PROJECT NAME: Wayne Johnson Community Center Rebuild

SOLICITATION NO: B191051

RE: ADDENDUM #1

ADDENDUM NO. 2

1 KITCHEN ELEVATION
 A-501 1/2"=1'-0"

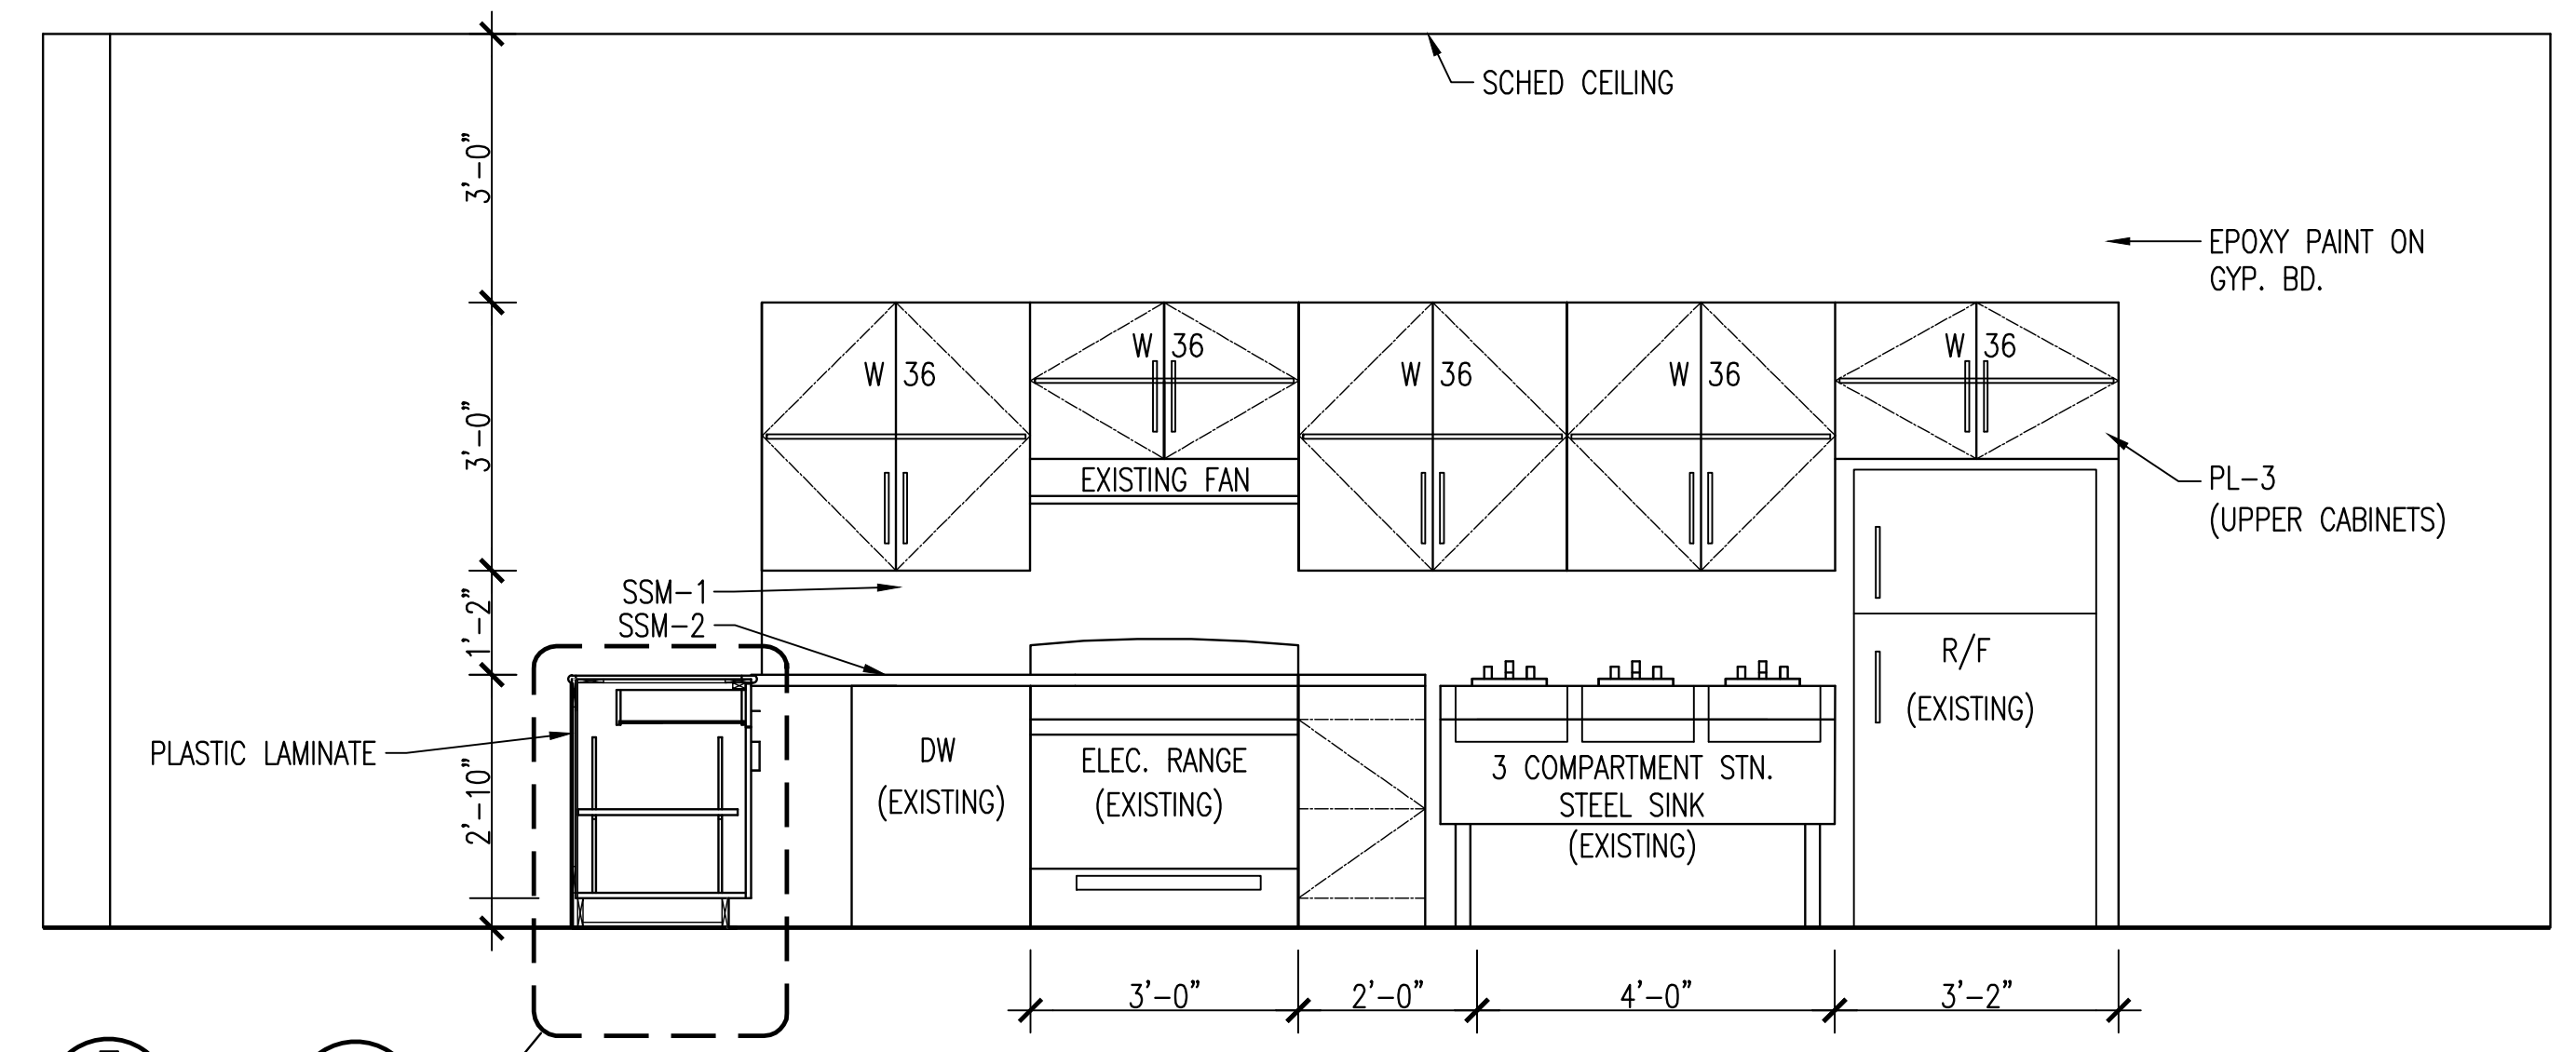
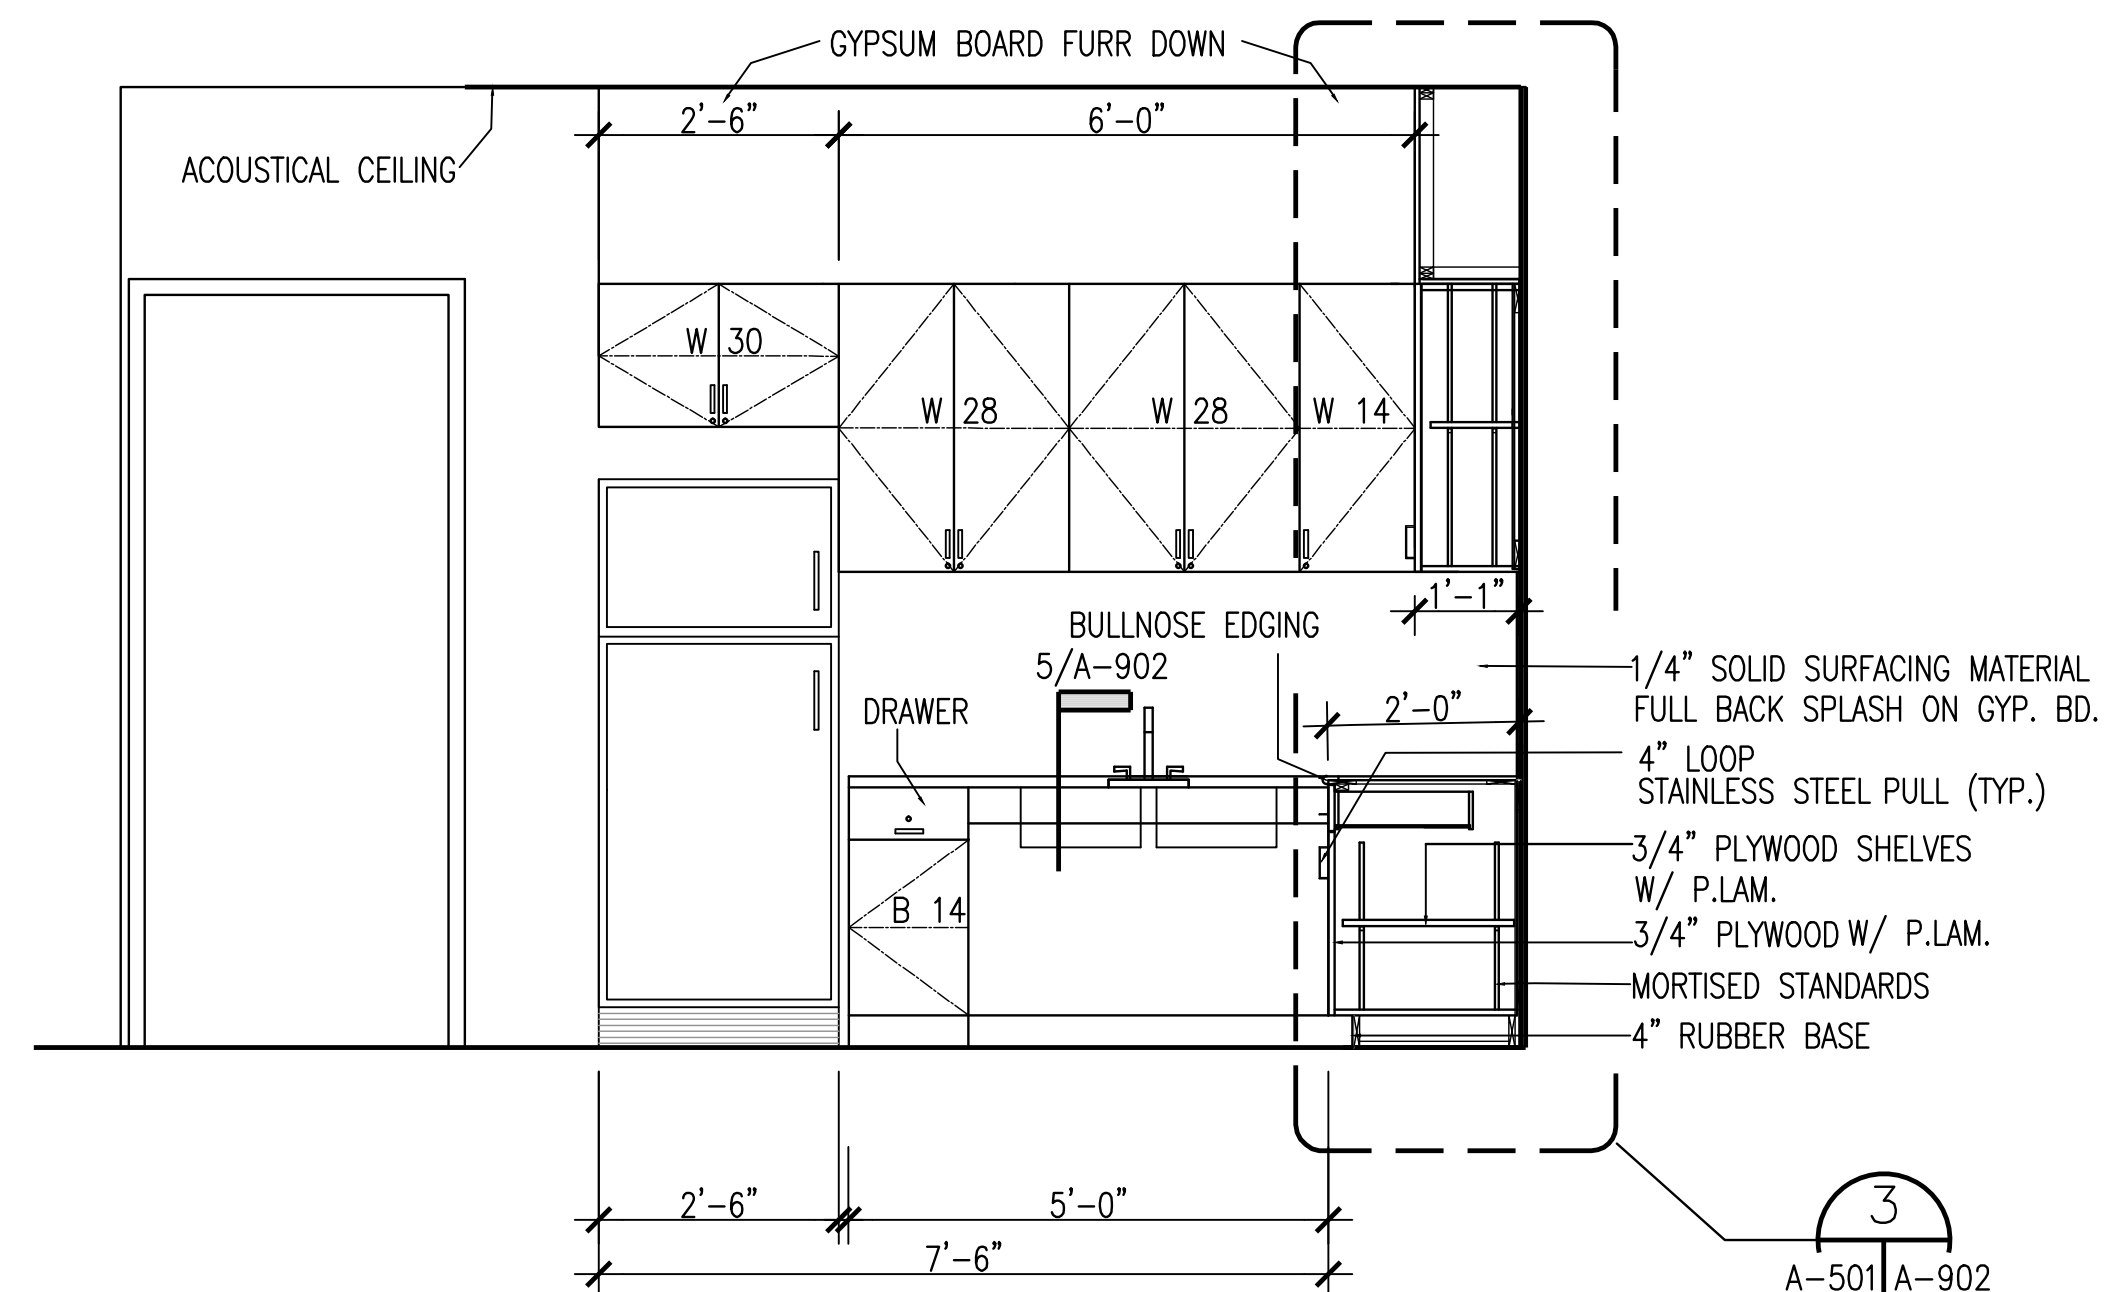
Question #7: *The re-issued drawings indicate a ¼” thick full coverage solid surface backsplash in the breakroom. This is not called out on the Scope of Work document. Do we include this, and if yes, please provide the correct product.*

Response: Yes. Product is specified in Section 064023 Paragraph 2.1.E. Manufacturer: E.1. du Pont Nemours and Company (Corian product) for solid surfacing materials (SSM).

1 FLOOR PLAN - ROOM IMPROVEMENTS
A-101 1/8"=1'-0"

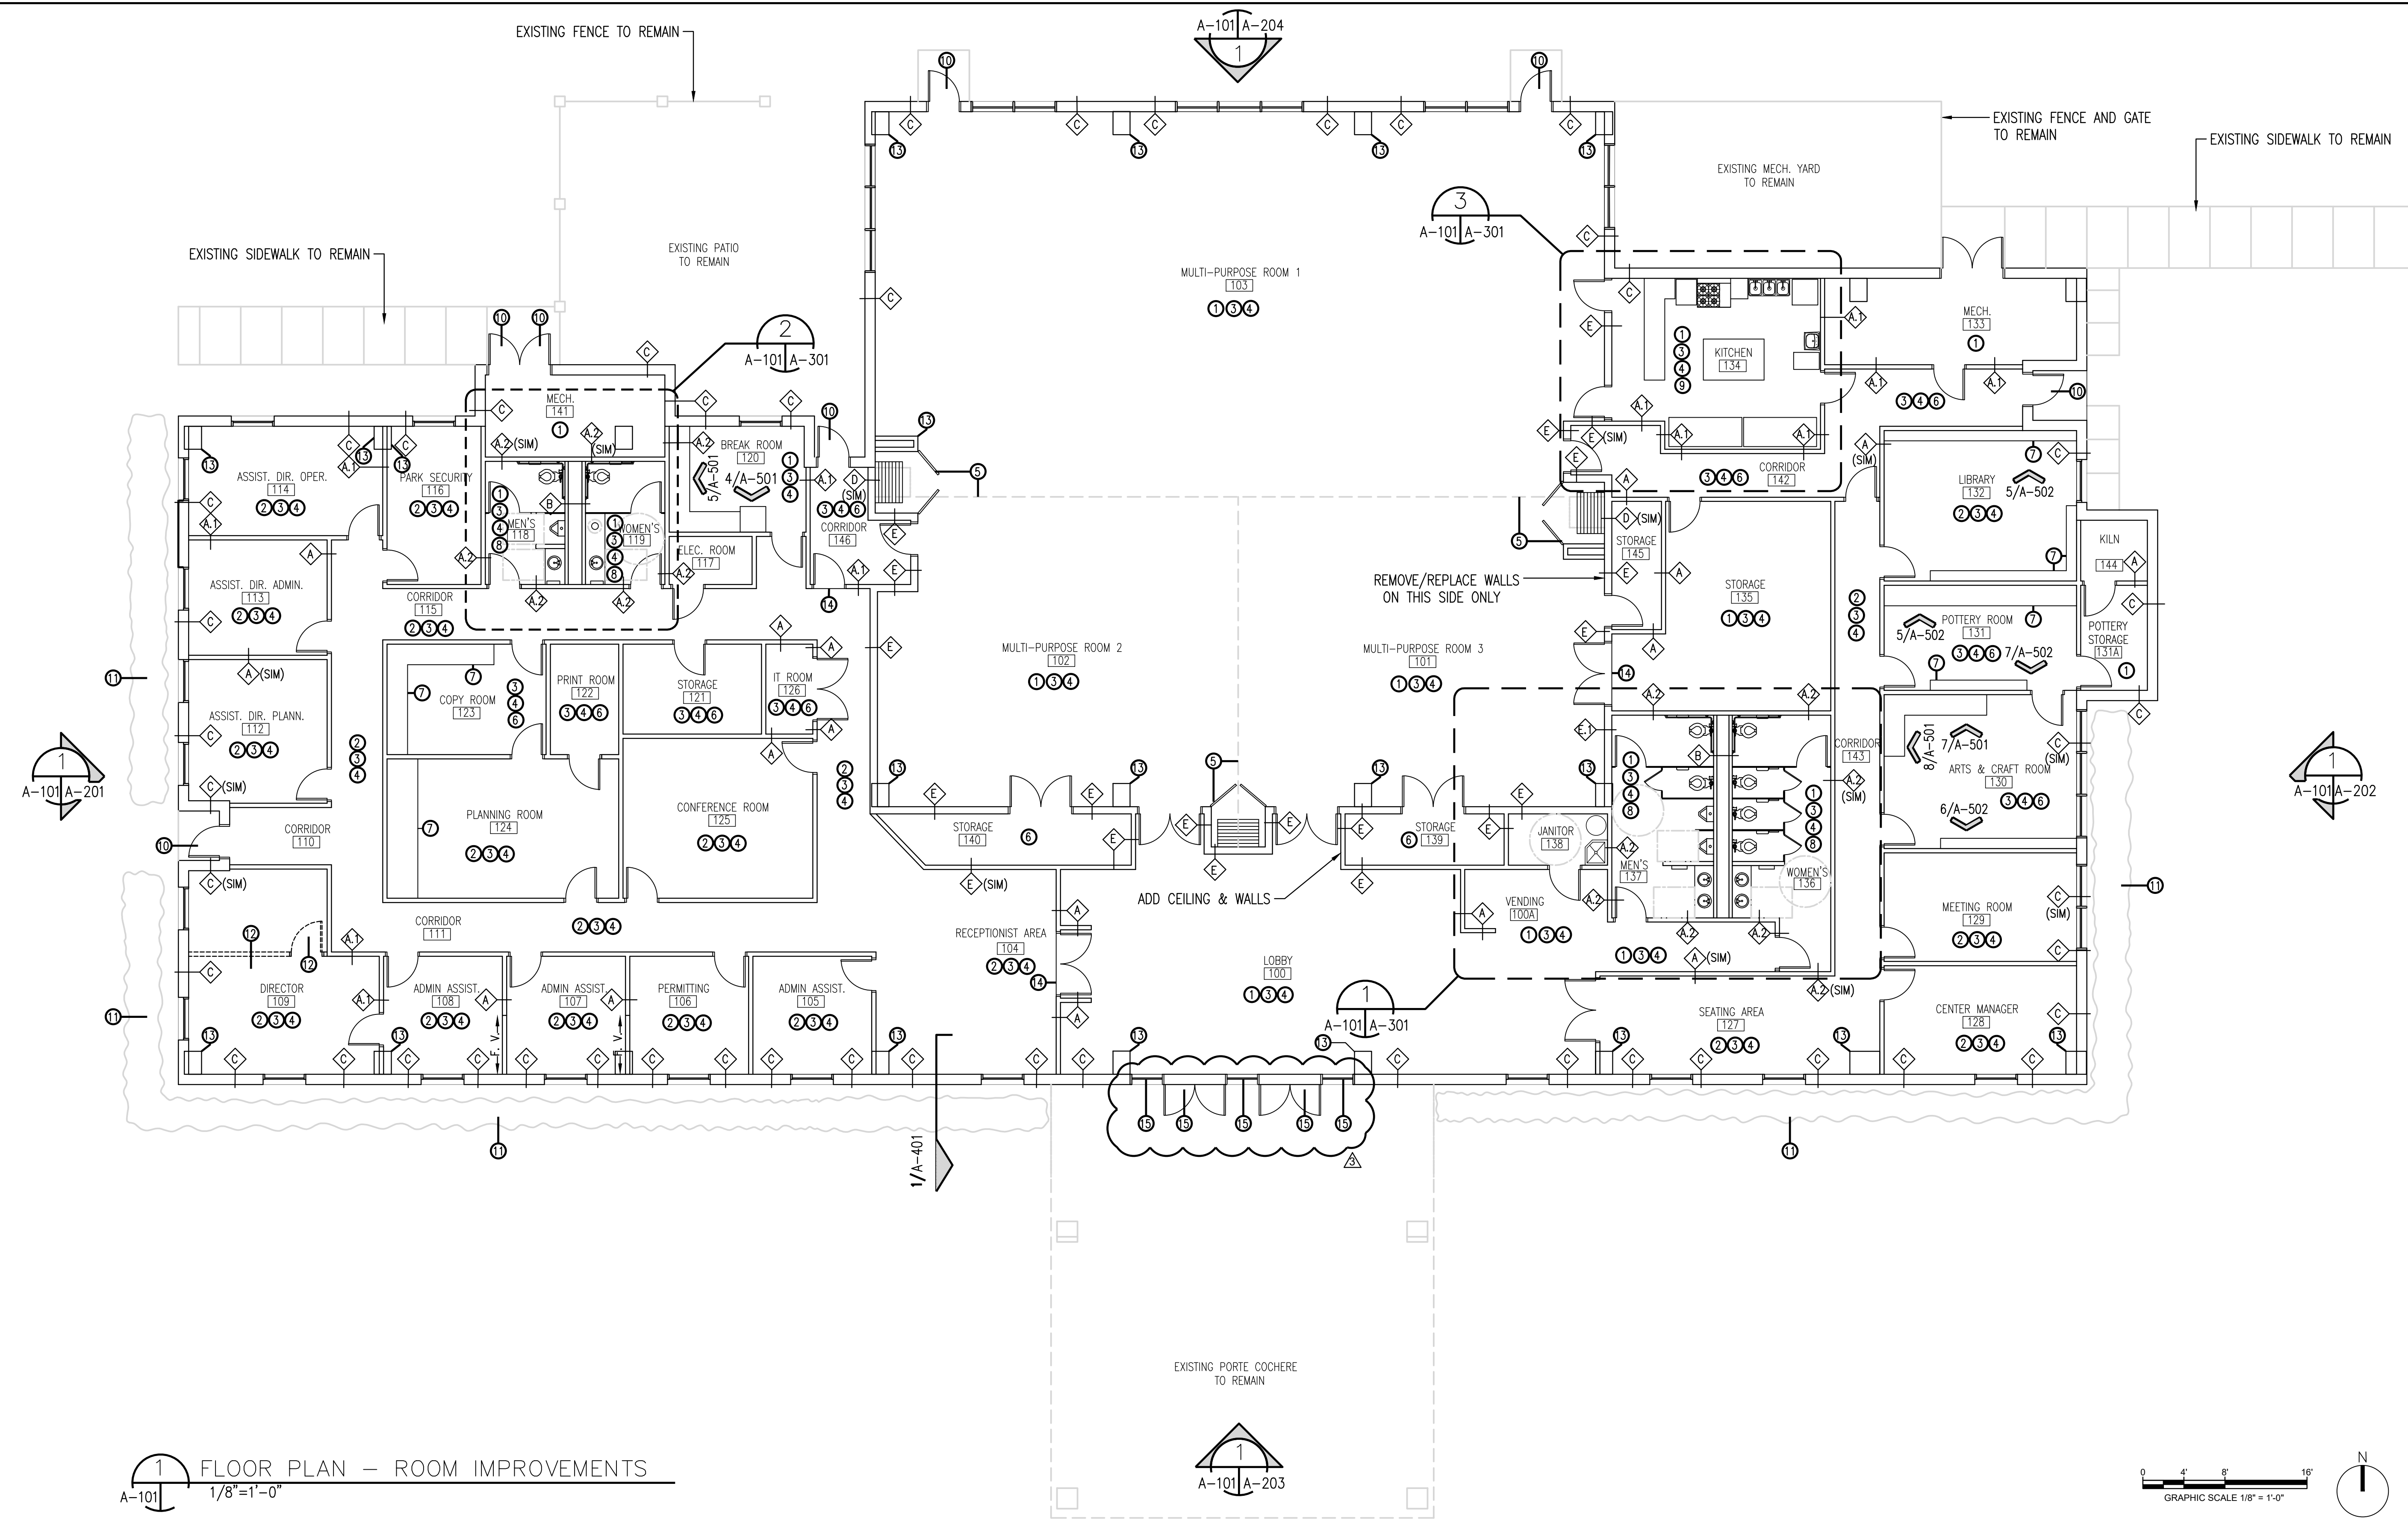
1. Sheet A-101 Floor Plan Room Improvements

Remove Sheet A-101 Floor Plan Room Improvements and Replace with revised Sheet A-101 Floor Plan Room Improvements attached herein.
